**Subject:** FAQ 17 status  
**Creation Date** 5/3/2007 1:30:15 PM  
**From:** Charles Moulton

Please find the attached revision 5 to FAQ 06-0008 for submittal. Two versions are included showing both changes hidden and changes shown. If you have any questions please give me a call.

Plant: Harris

Figure B-4 General Process to Transition Operator Manual Actions

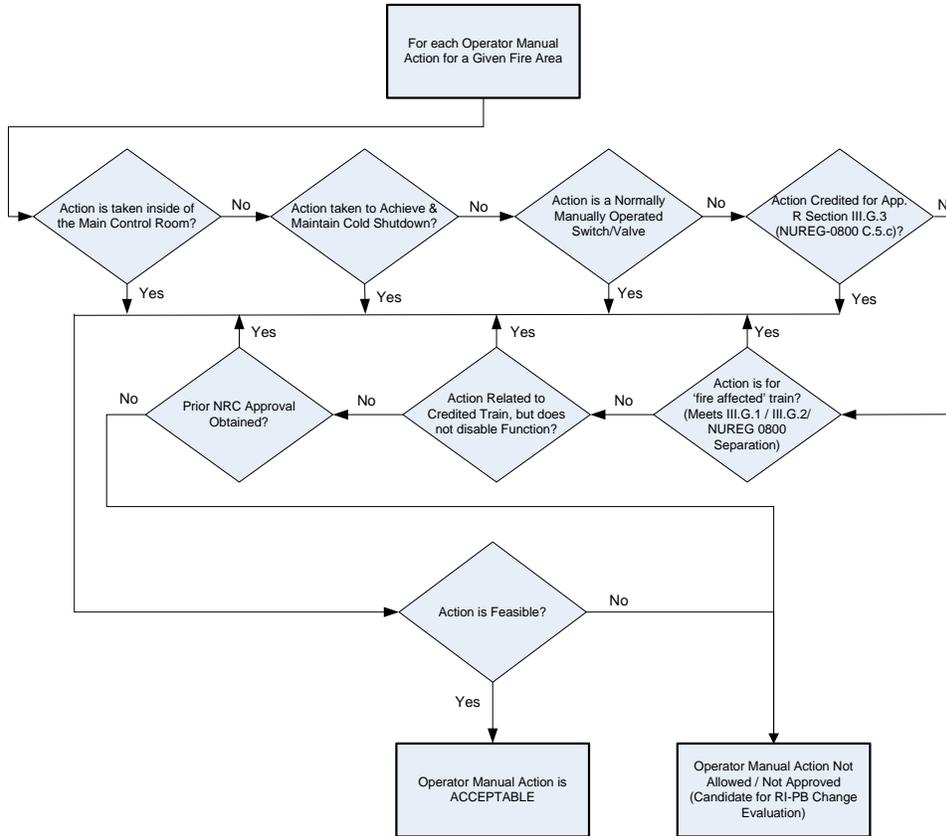
Figure B-4 depicts this general process for determining whether a transitioning operator manual action to NFPA 805 recovery action requires a change evaluation.

Deleted: s

Deleted: 2

Figure B-7. Allowed Operator Manual Action – In Credited Success Path – Common Tank Suction

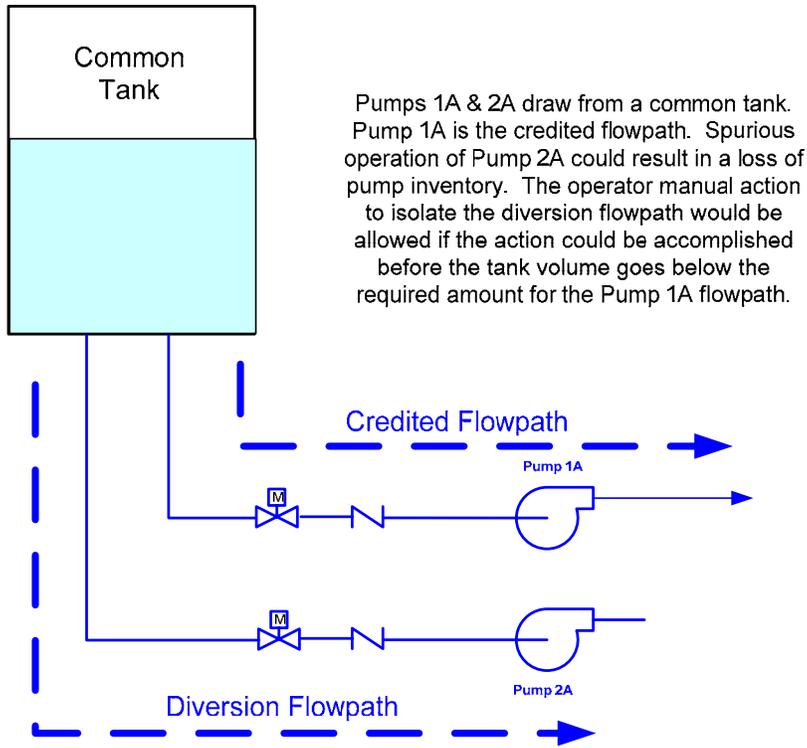
During the June 9, 2006 public meeting the following example was specifically discussed: *Two redundant trains taking suction from a common tank. Provided the manual action can be accomplished prior to the tank volume going below the minimum required volume to support the credited function the action would be allowed and therefore not require a change evaluation. (Figure B-7)*

Deleted: 6

Deleted: 2

Figure B-8, Allowed Operator Manual Action – In Credited Success Path – Auxiliary Feedwater Flow Diversion

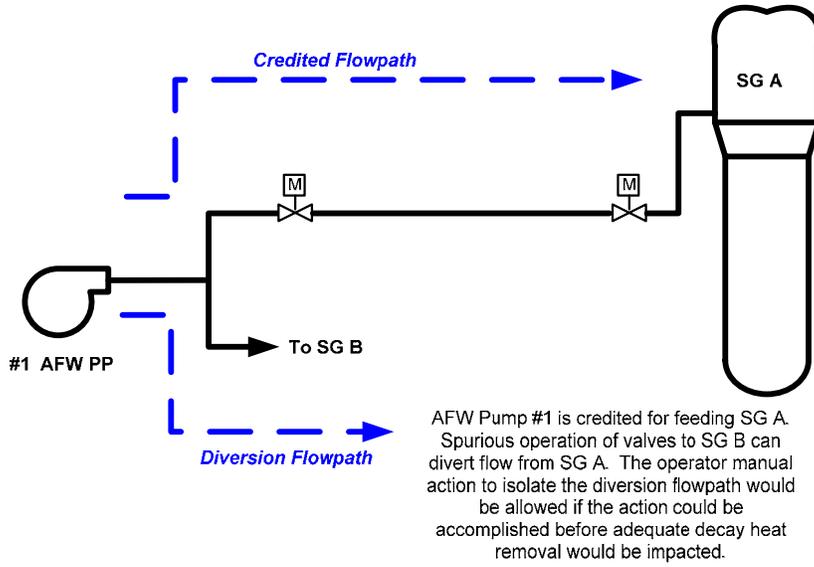
A second example is the credited function is to inject water to the Steam Generator (reactor) and a spurious actuation causes a diversion from the credited flow path. Provided the minimum required injection flow can be maintained and the operator action can be accomplished prior to the function being disabled. (Figure B-8)

Deleted: 7

**Figure B-4 General Process to Transition Operator Manual Actions**

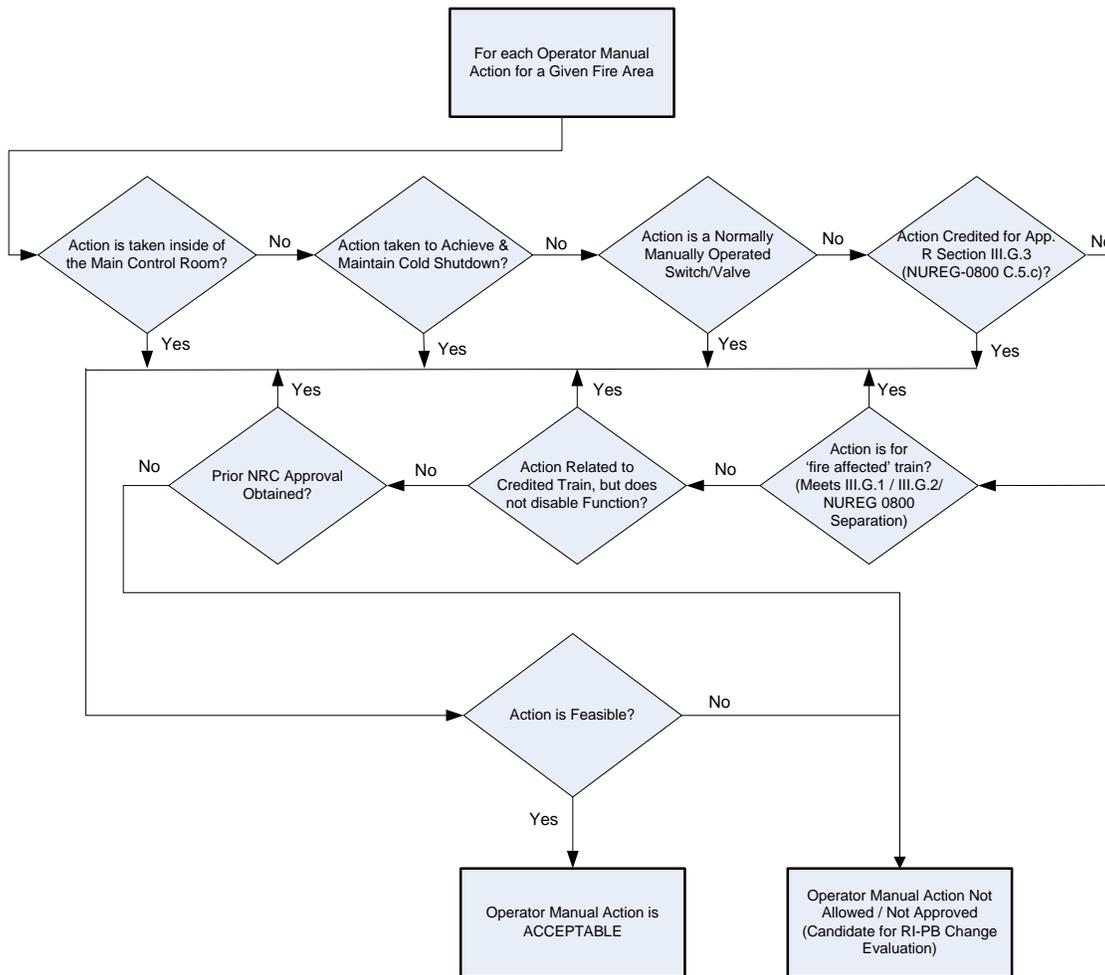
Figure B-4 depicts this general process for determining whether a transitioning operator manual action to NFPA 805 recovery action requires a change evaluation.

**Figure B-7 Allowed Operator Manual Action – In Credited Success Path – Common Tank Suction**

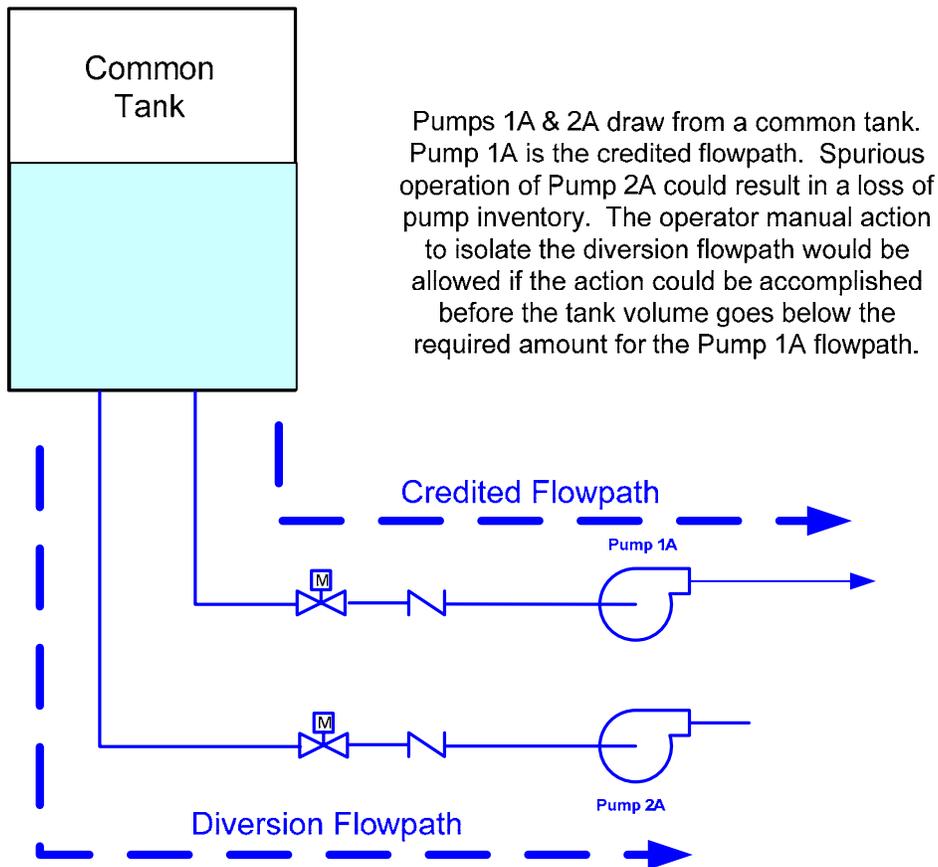
During the June 9, 2006 public meeting the following example was specifically discussed: *Two redundant trains taking suction from a common tank. Provided the manual action can be accomplished prior to the tank volume going below the minimum required volume to support the credited function the action would be allowed and therefore not require a change evaluation.* (Figure B-7)

Figure B-8 Allowed Operator Manual Action – In Credited Success Path – Auxiliary Feedwater Flow Diversion

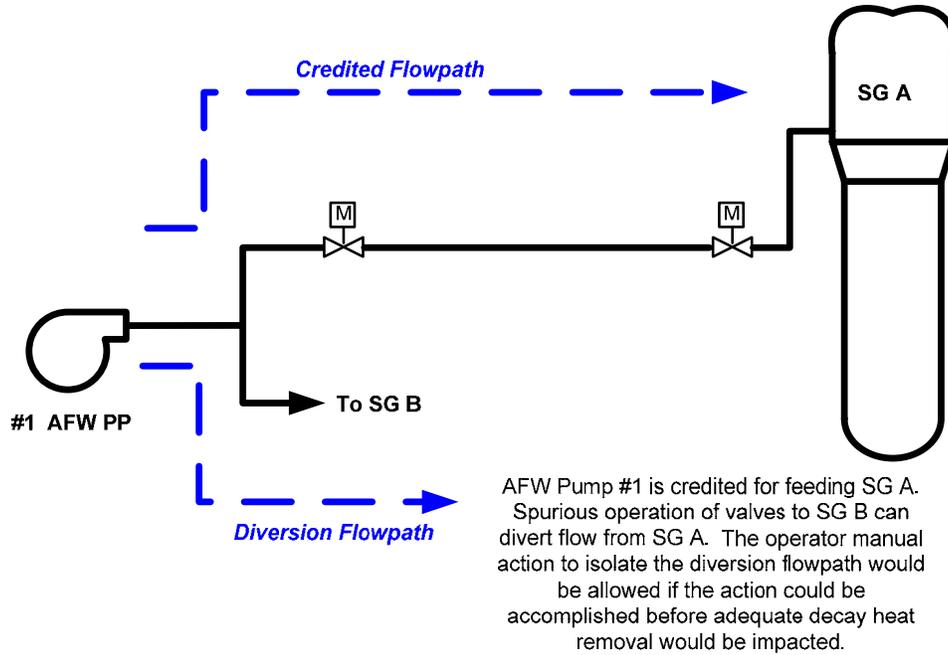
A second example is the credited function is to inject water to the Steam Generator (reactor) and a spurious actuation causes a diversion from the credited flow path. Provided the minimum required injection flow can be maintained and the operator action can be accomplished prior to the function being disabled. (Figure B-8)
